STAFF REPORT: FEBRUARY 7, 2024 MEETING

APPLICATION NUMBER: HDC2024-00022

ADDRESS: 14500 ARTESIAN

SCOPE: DEMOLISH GARAGE, ERECT NEW GARAGE, REMOVE TREES AND ALTER LANDSCAPING, REPLACE FENCE, PAINT HOUSE

Staff photos.

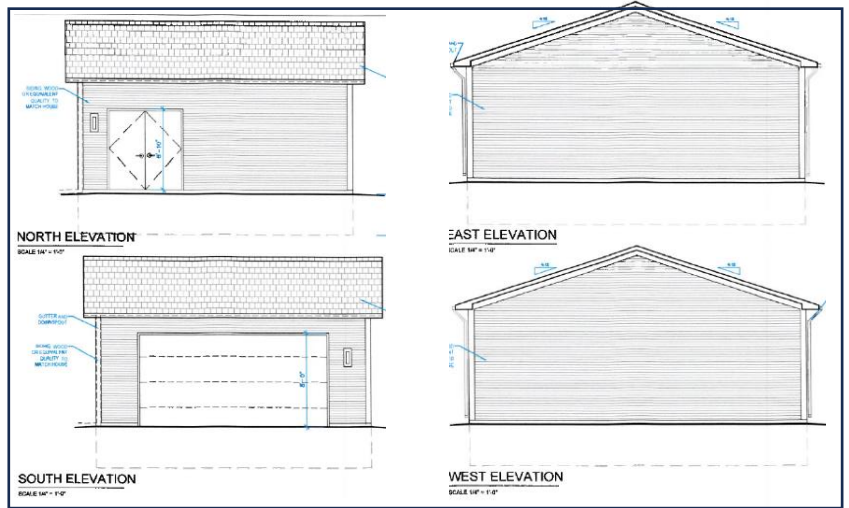
- The proposed design has a minimal aesthetic and is sympathetic to the dwelling's architectural design. The reverse gable would match that of the house and offer a commonality between structures. The applicant proposes smooth faced cementitious siding.
- Accordingly, staff assess that the garage is a contributing structure/resource to the Rosedale Park Historic District. A contributing structure is one that retains a high degree of architectural integrity, and was built during the period of significance for the district.

Staff photos.

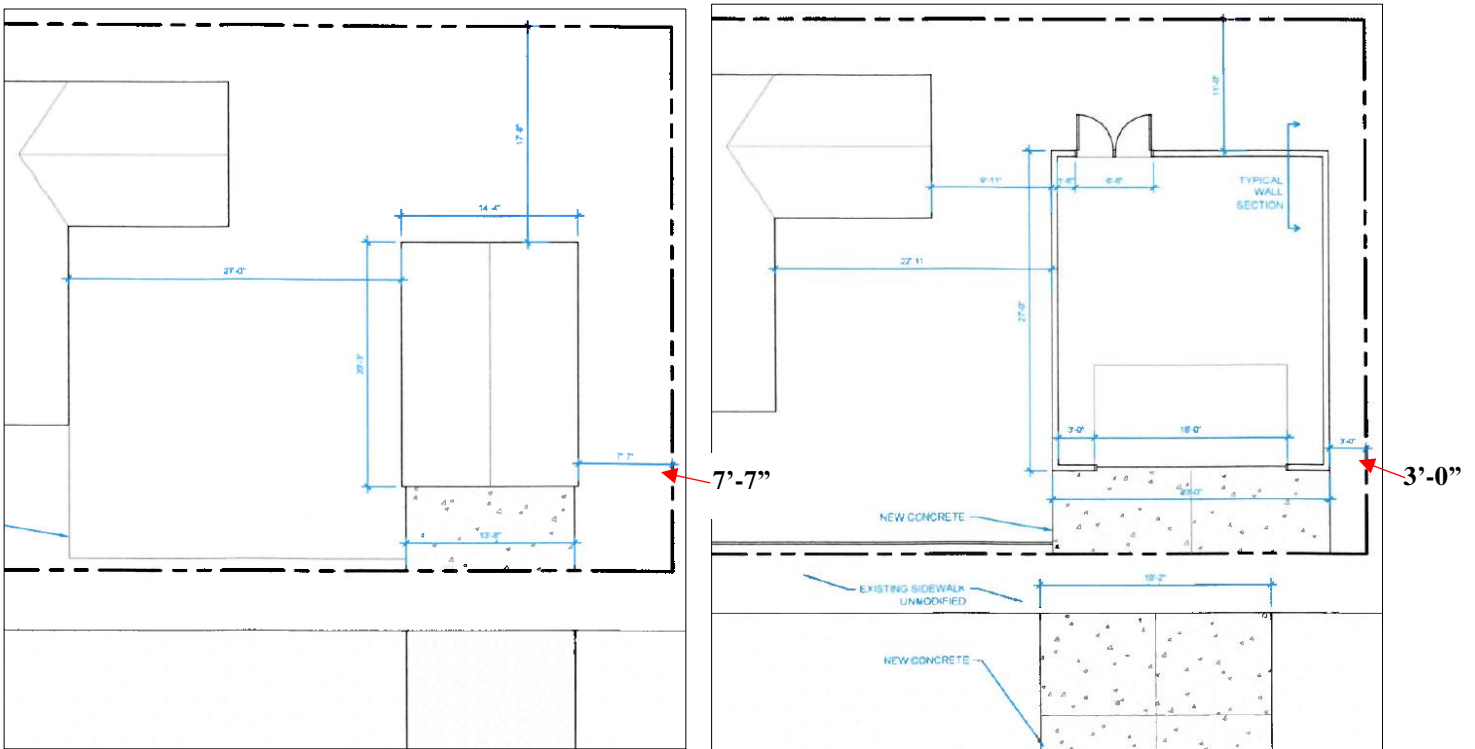
- The applicant and staff photos, two of which are below, show evidence of deterioration and structural issues. However, it is staff's opinion that the level of deterioration does not appear to be so severe that repair remains a viable option.

The southeast corner is sinking — as seen by the wood siding angling downward. The centers of the east and west walls are buckling in the center, as well as at the center of the roof. ★

Existing conditions at adjacent front-facing garages. 14500 Artesian is identified by a star.

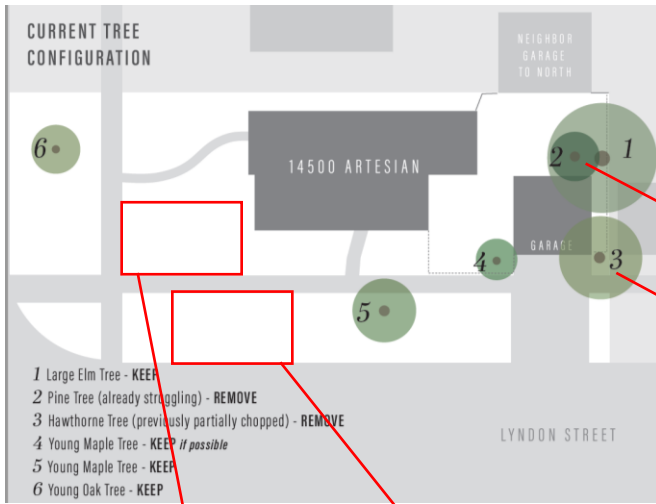
- According to the site plans, the width of the new garage will be 8’-4” wider than existing (14’-4” existing - compared to 23’ proposed) and 6’-9” deeper (20’-3” existing – compared to 27’ proposed).

- The existing site plan states that there is a distance of 7’-7” to the property line, which would be reduced to 3’-0” with the new garage. However, as the photo shows on the following page, it appears as though there is about seven feet between the garages, not seven feet to the applicant’s property line.

- Staff isn’t clear on why the concrete drive between the sidewalk and street doesn’t line up with the wider concrete pad proposed at the garage itself.

Applicant photos.

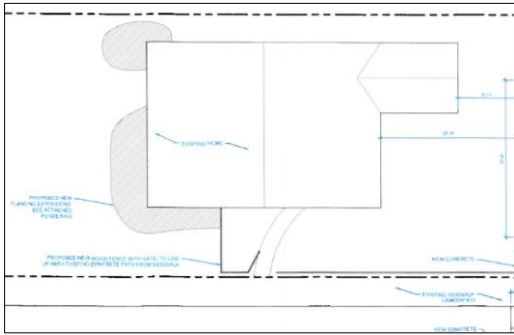
- Staff has two concerns related to the proposed landscaping.
 - The placement of the arborvitae and maple tree are very close to the house and porch. Adequate spacing must be given so the branches and roots won't cause damage to the historic structure.
 - The arborvitae and maple, if not maintained, can grow to substantial heights, and would restrict the view of the front elevation of the house.

- One tree will be planted on the property to replace the formerly substantial shade tree located adjacent to the rear yard sidewalk and garage. The location and tree species will be submitted for staff review.
- A revised landscape plan will be submitted for staff review.
- Confirmation of the physical support for the fence, along with a color sample and specification for the opaque fence stain, will be submitted for staff review.
